City of Tualatin

December 03, 2015

SUBDIVISION REVIEW FINDINGS AND DECISION FOR SB15-0002, SAGERT FARM

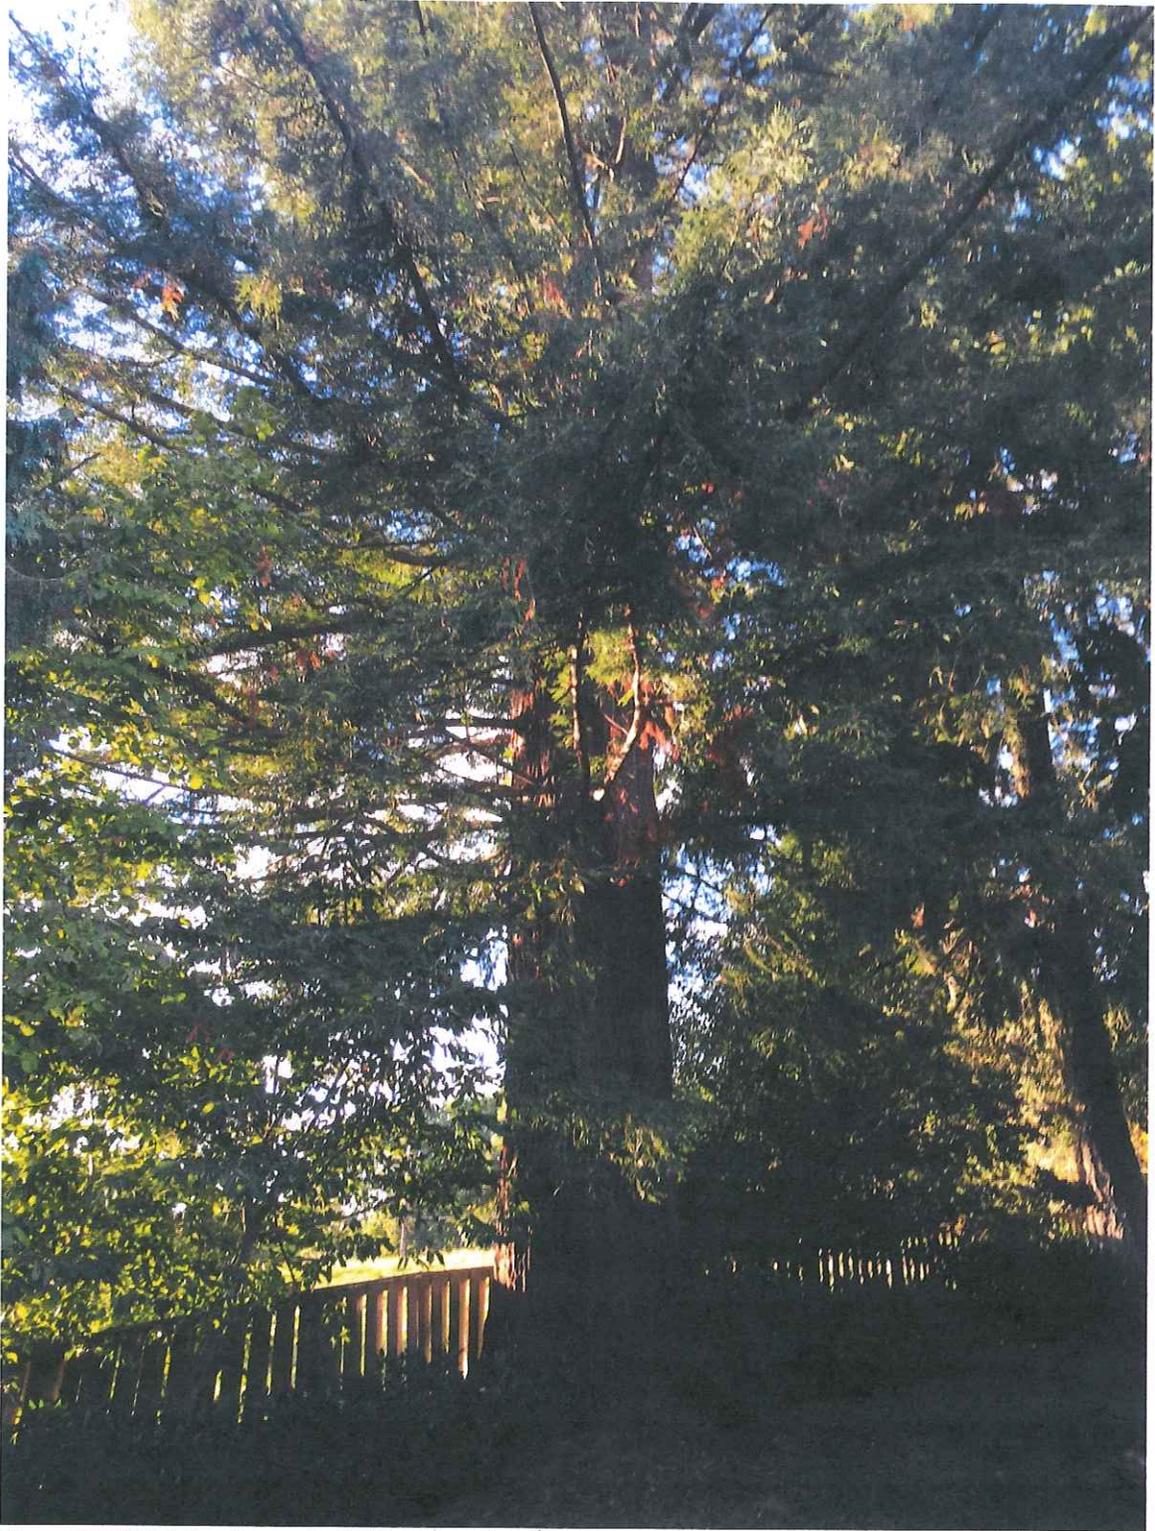
My biggest concern is regarding tree # 10982 (Redwood; 66" DBH; 28' C-Rad; Excellent condition). The tree is mostly on my property, but may have some trunk in the subject property. You recommended the tree for "retain". This tree has the largest DBH of all surveyed trees.

1. Why did you not give the recommendation to "Protect off-site tree" for tree # 10982? You gave tree #10979 (redwood with 10" DBH) 100' to the north the recommendation of "Protect off-site tree", but not tree #10982.
2. What is the recommended setback distance for construction activity (grading, earthmoving, foundations, nonporous surfaces) from a large redwood tree? I assume if is no closer than the dripline – but I would like your professional opinion.

The second tree I am concerned about is tree #10981 (Douglas Fir; 30" DBH; 24' C-Rad; Good condition).

1. What is the recommended construction setback for this Douglas Fir (tree # 10981)? Is it at the dripline?
2. Will tree #10981 be exposed to additional windthrow when tree #10978, 10977, and #10980 are removed?

MAP 1

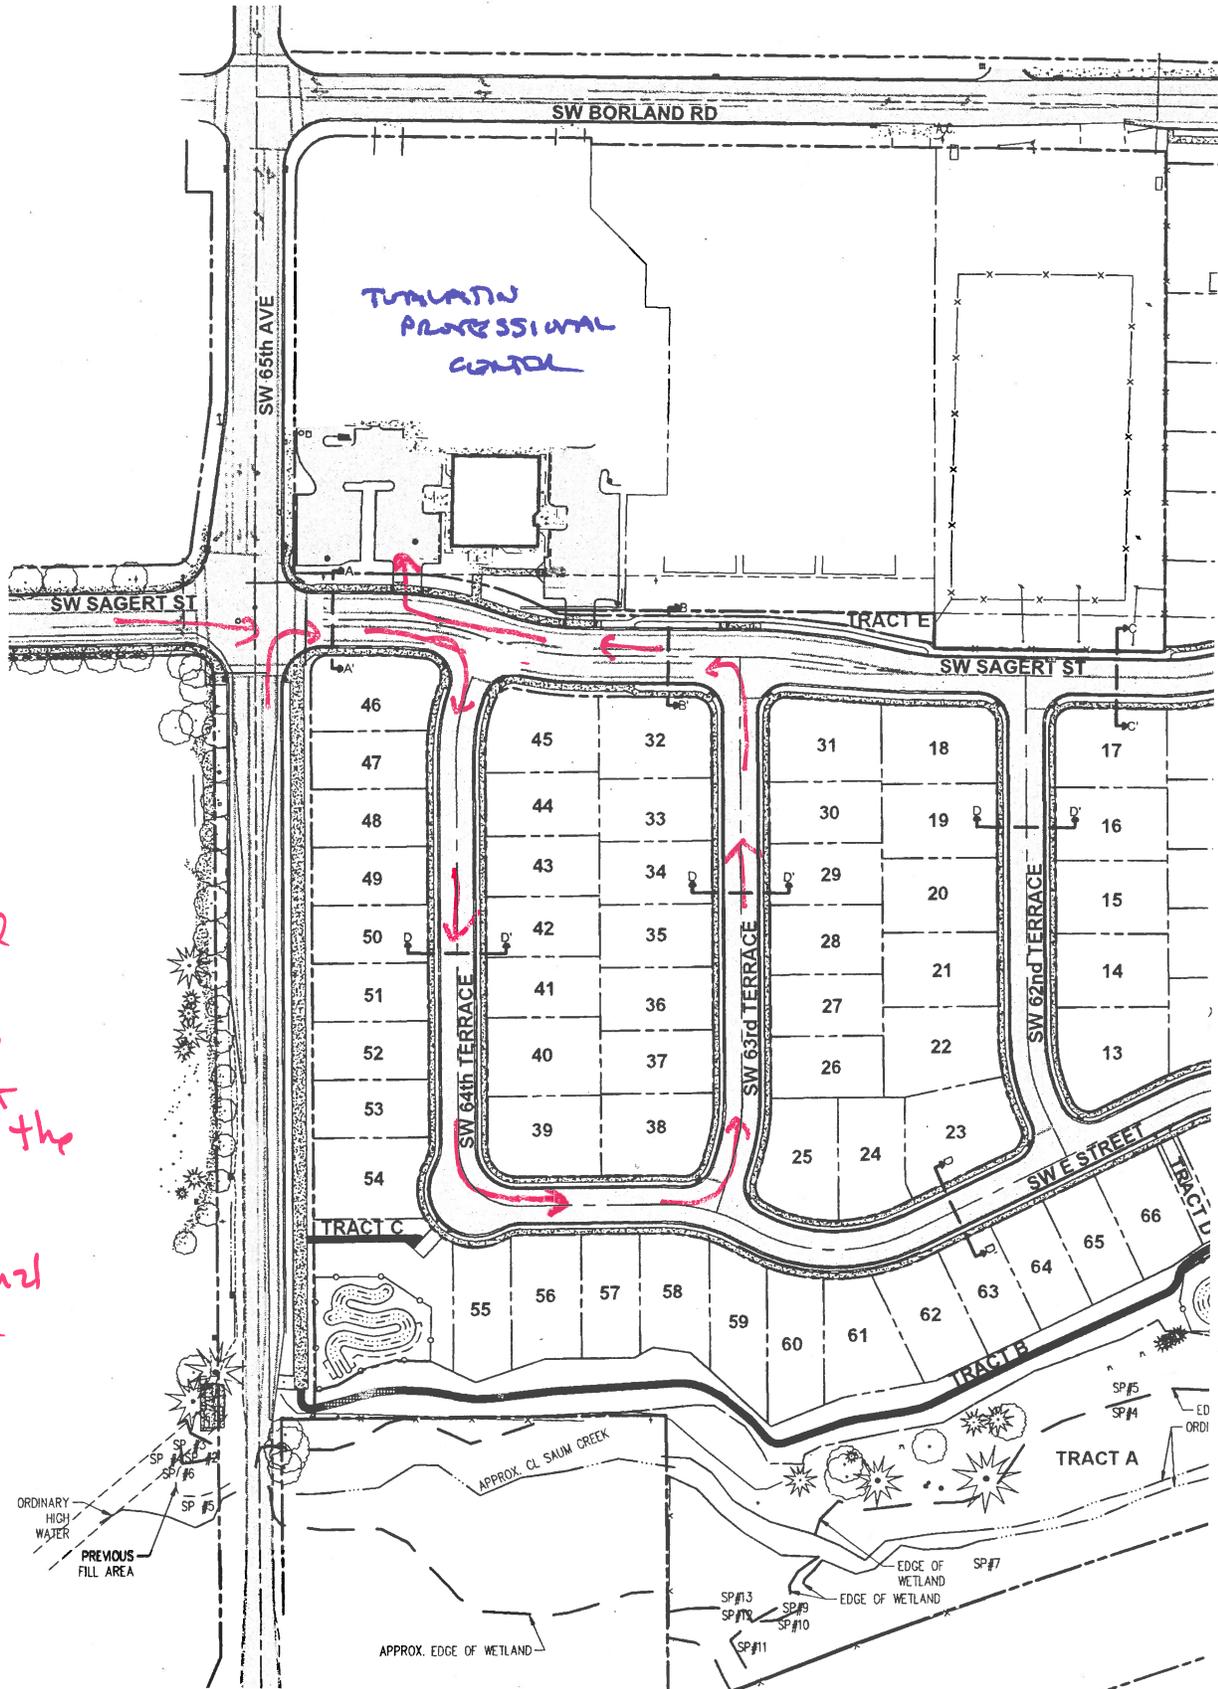
One awkwardness in the application is that Lennar proposes to remove some improvements that are on the Center property, such as the rock retaining wall that supports the Center's east parking lot (item 13 on Sheet C111 of the plans), the seven parking spaces (item 1 on Sheet C111), the storm drain (item 8 on Sheet C111). Another awkwardness is that Lennar proposes to place some temporary inlet protection around drains on the Center property (item 2 on Sheet C121) and, I think, to close the Center's access to Sagert Street during construction (item 3 on Sheet C121, "construct/maintain stabilized construction entrance per city std. drawings"). The existing Sagert Street is not simply a private driveway within a public street, but represents a half-street which the developer of the Center paid for.

Lennar's proposed access route to the west part of the Tuzlizin Professional Center

MAP 2

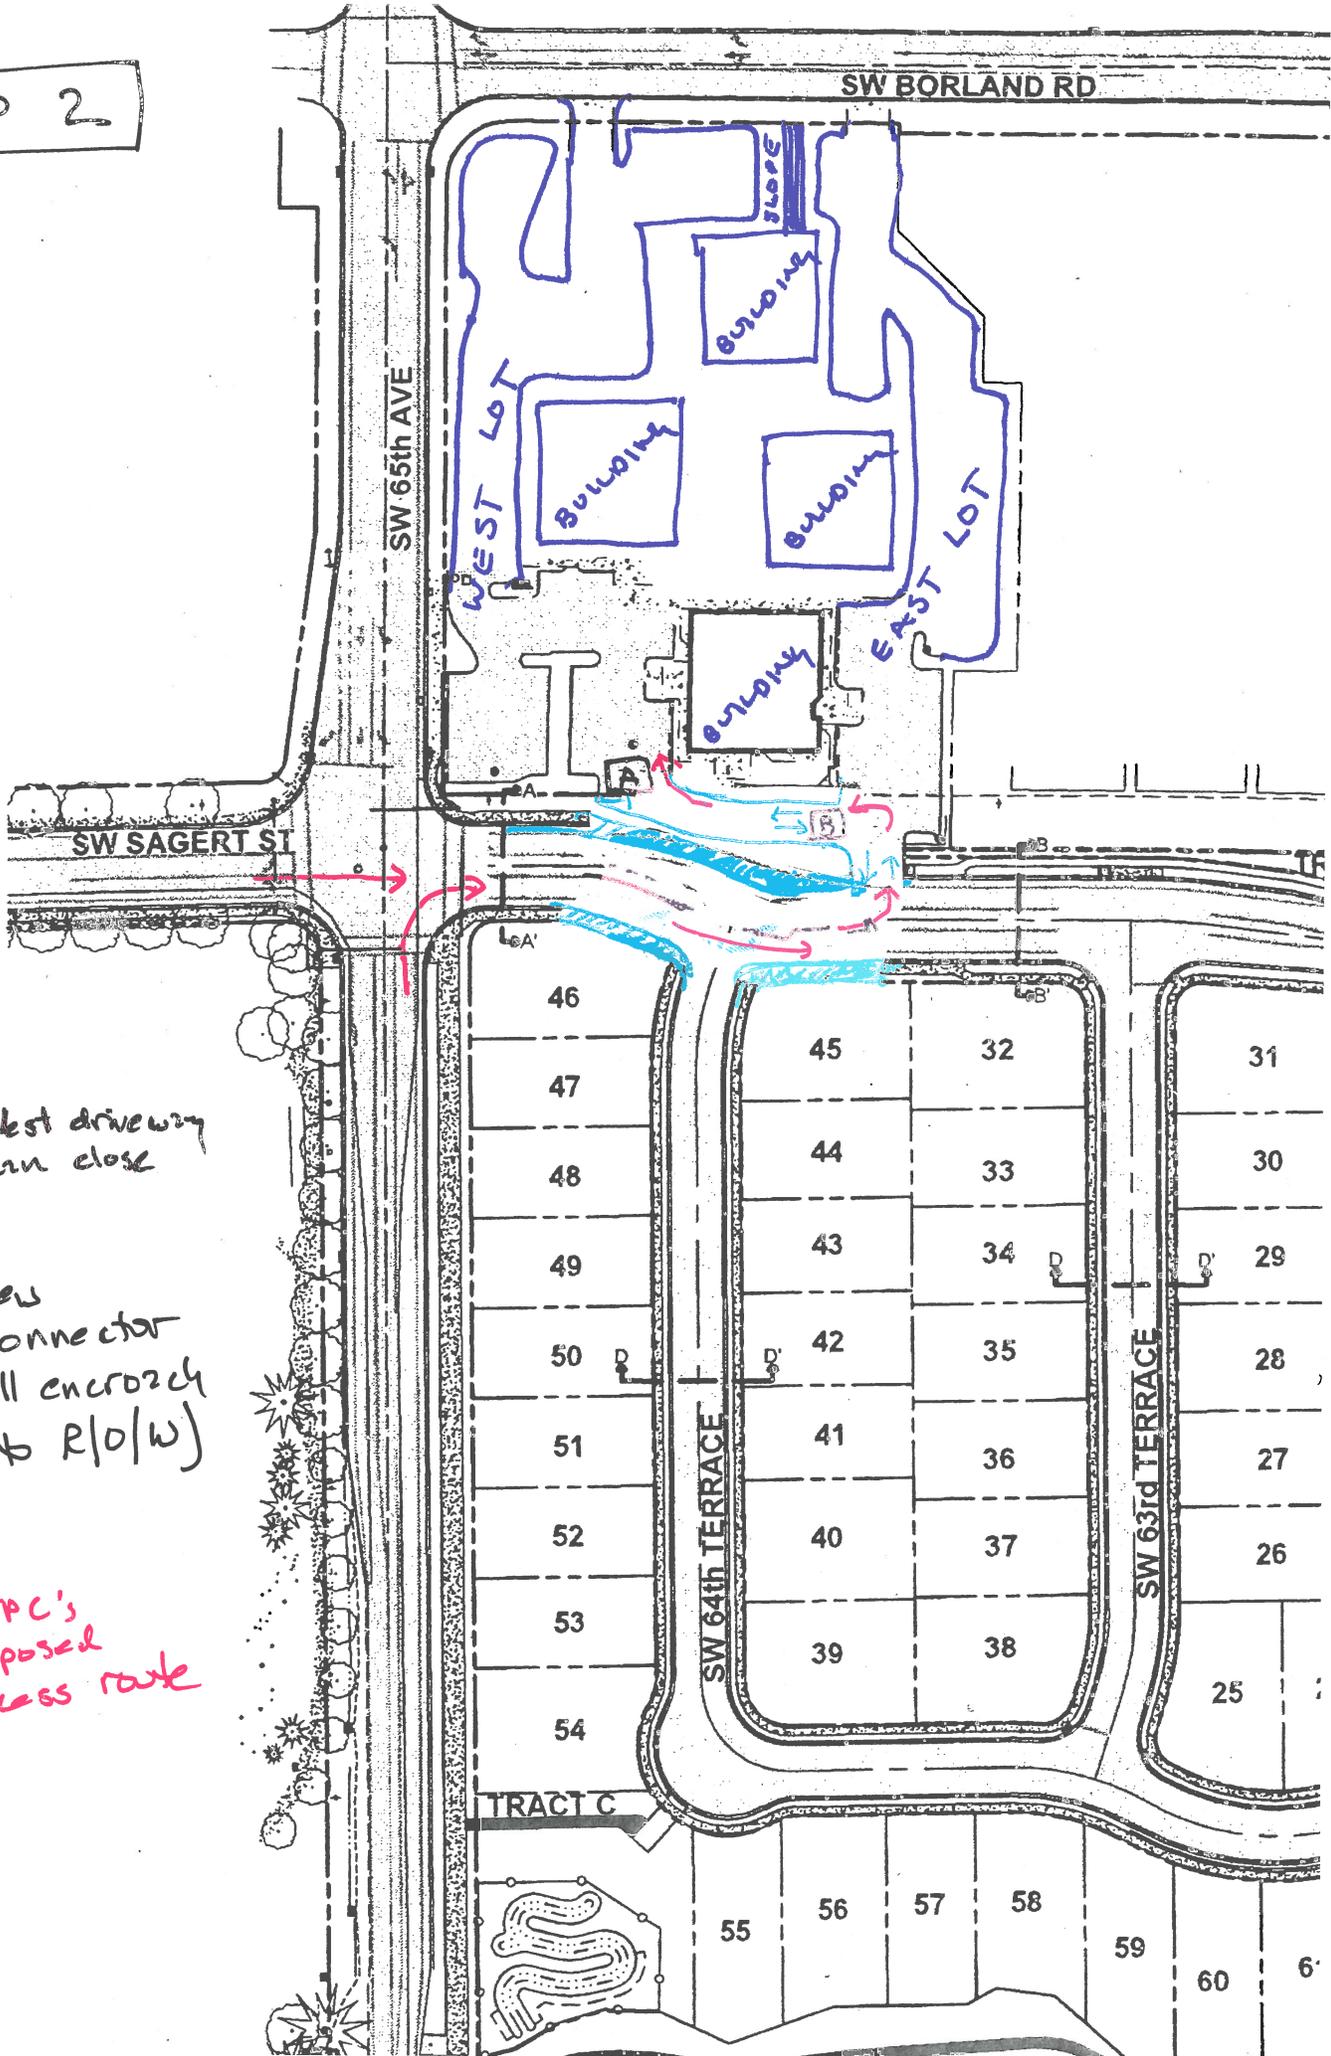
A West driveway can close

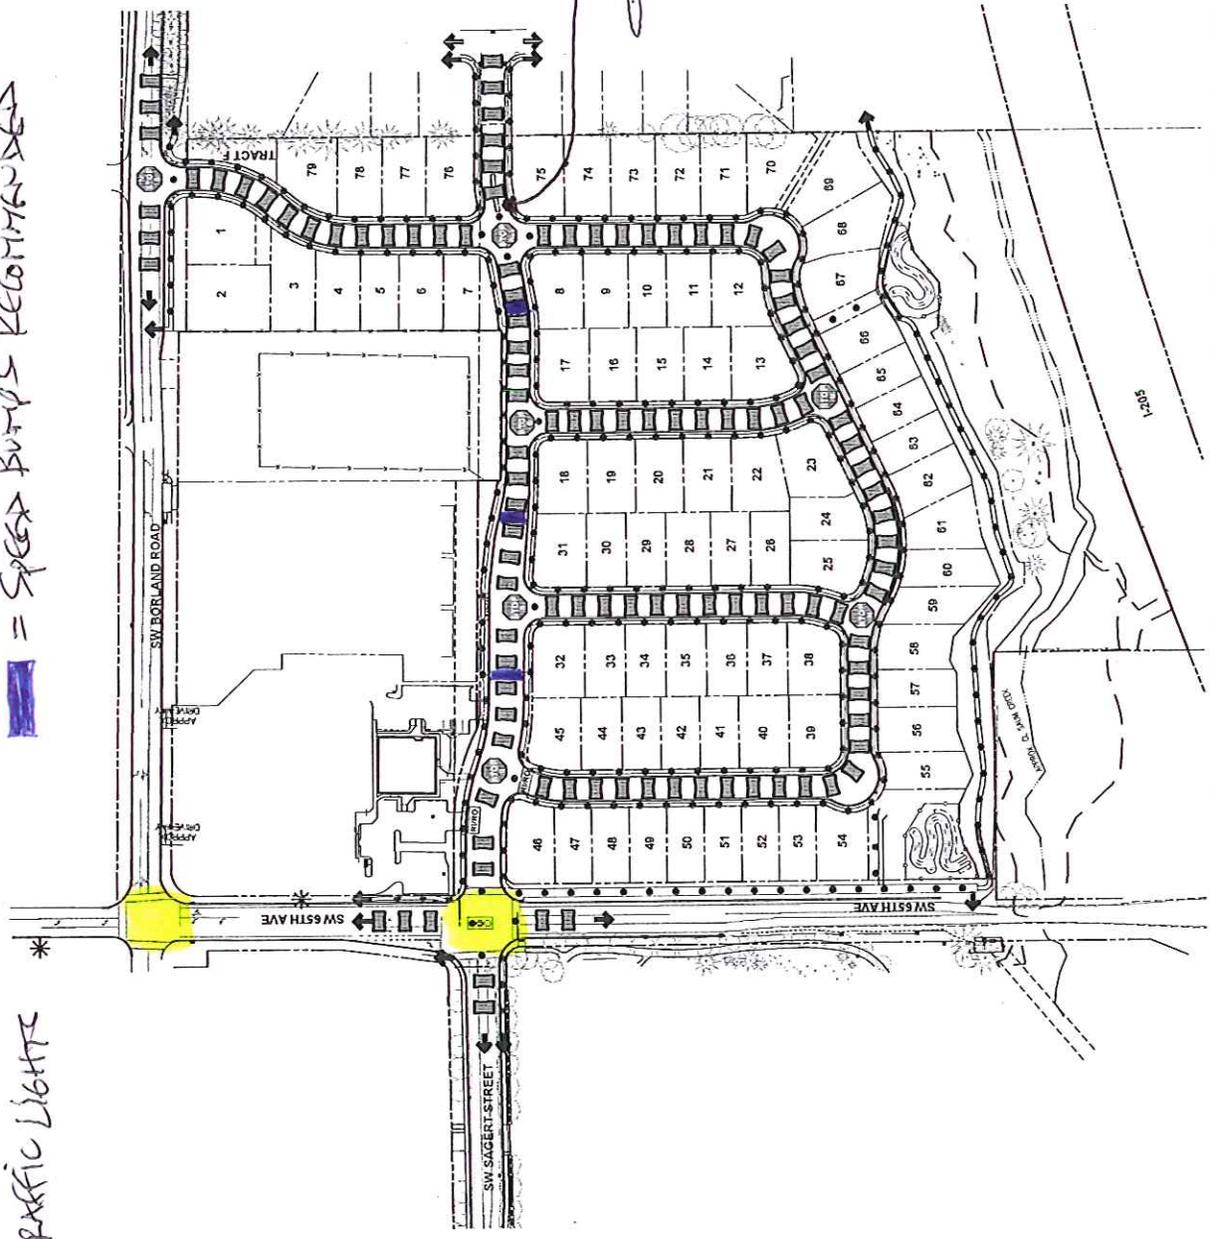
TRAFFIC LIGHTS

SPEED BUMPS RECOMMENDED

IS THIS A LANDSCAPE HIGHWAY?
